VERMONT YANKEE NUCLEAR POWER CORPORATION

November 12, 1982

Subject: Alternate Shutdown System

ADDITIONAL CLARIFICATION

FIGURE 7

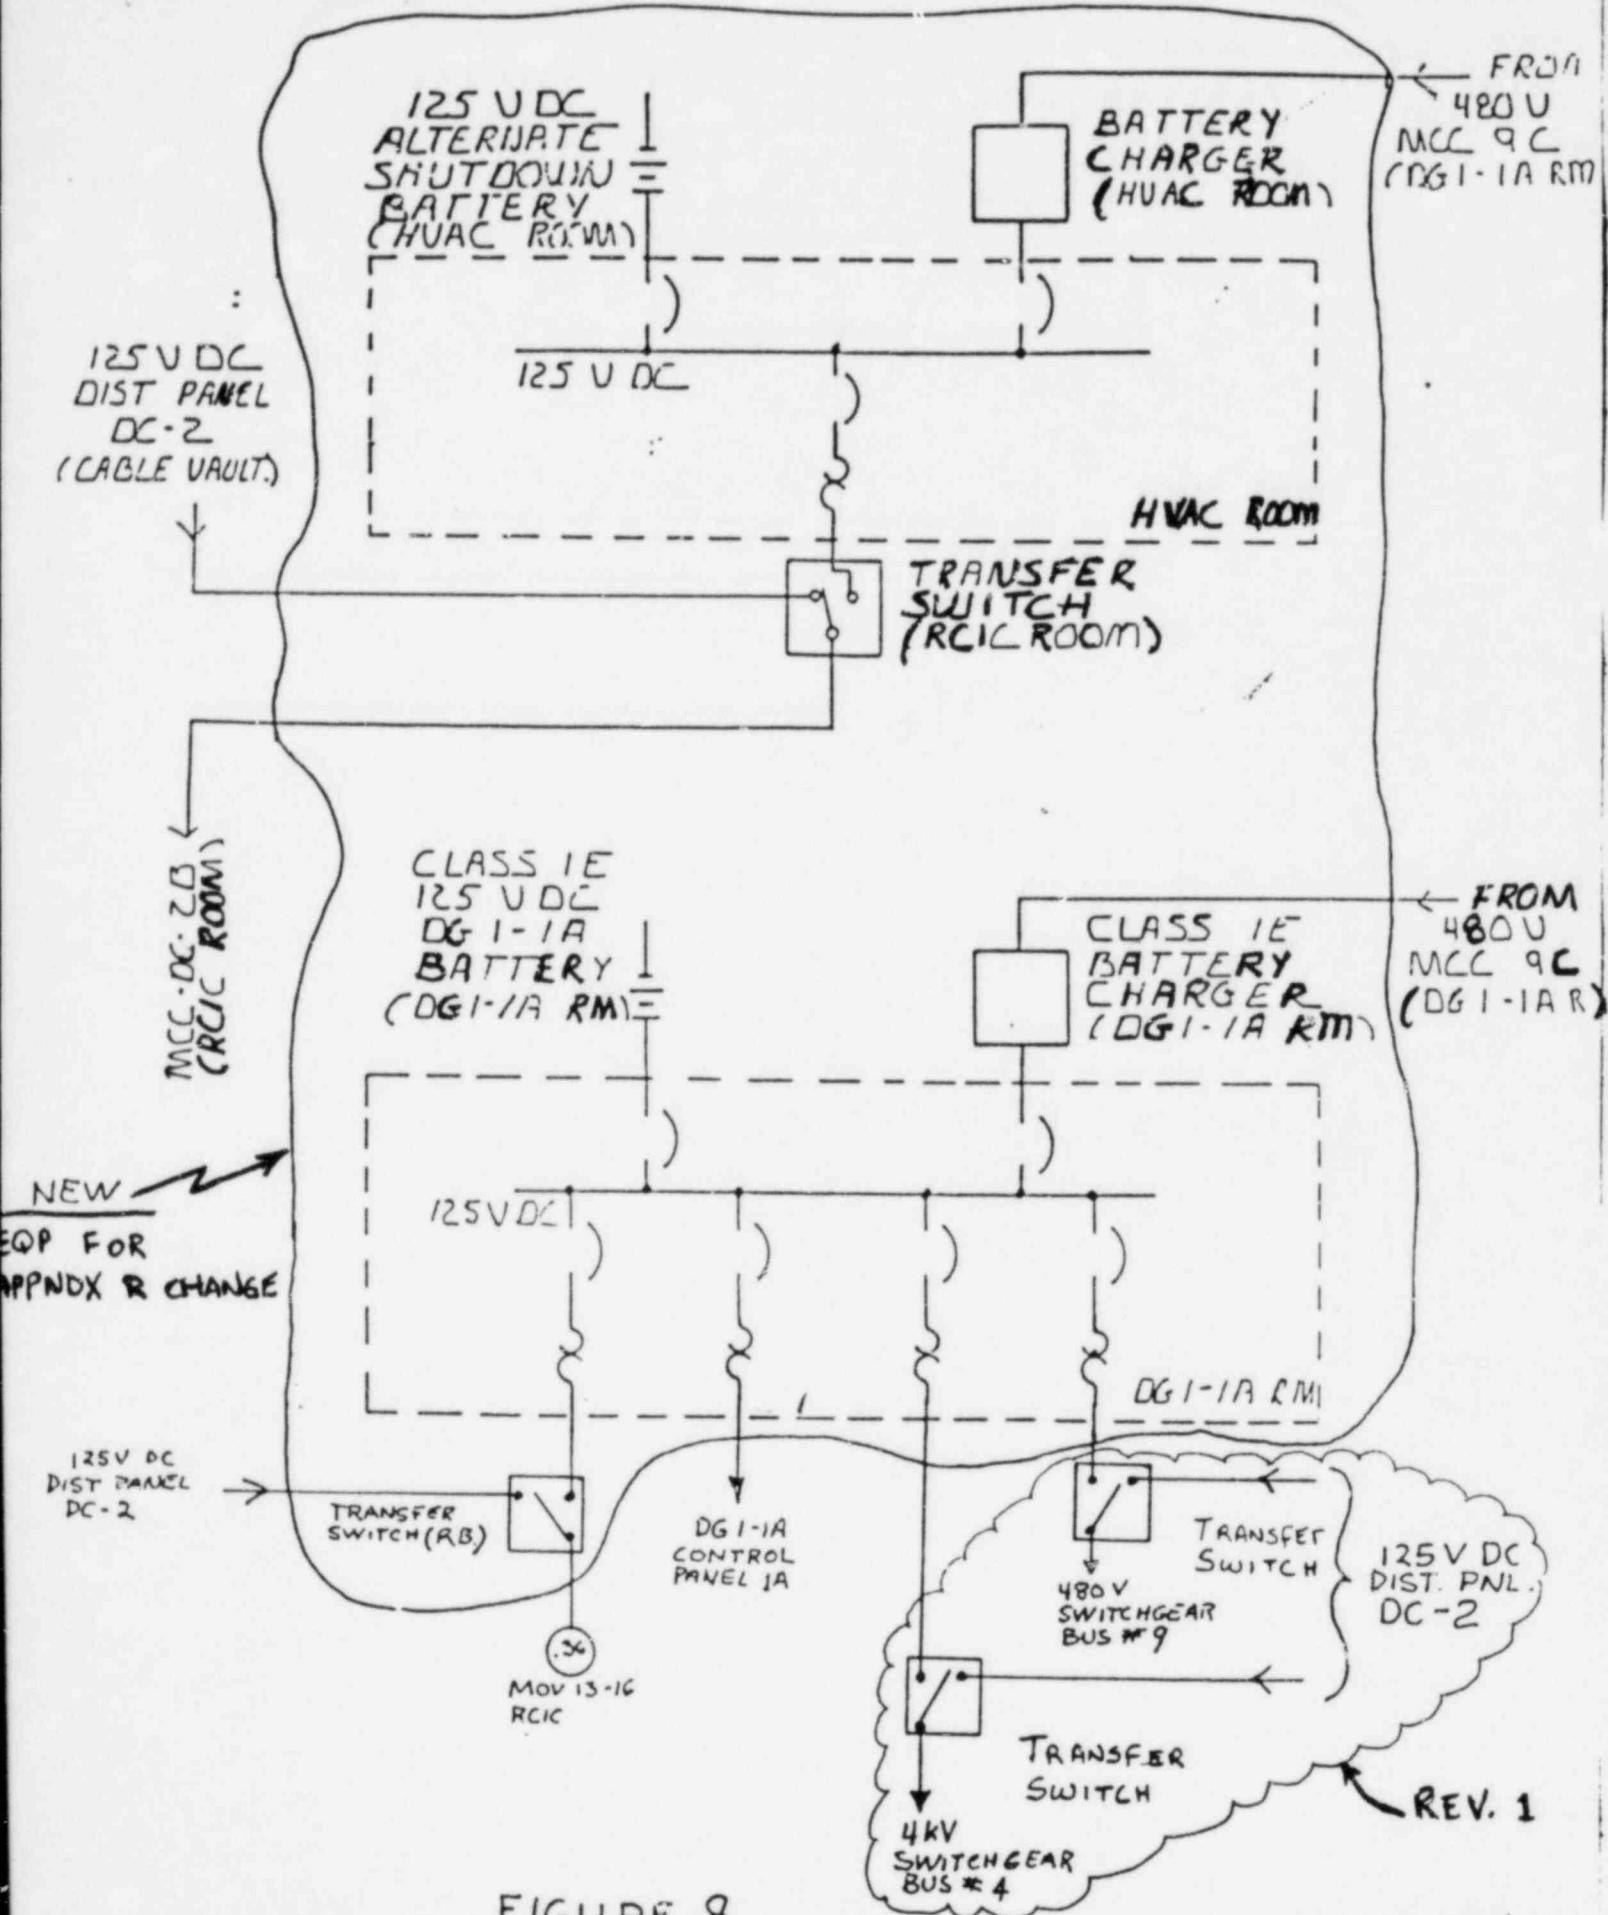
Figures 2 and 7 have been revised to show changes to equipment locations. These should also be inserted in place of those originally submitted.
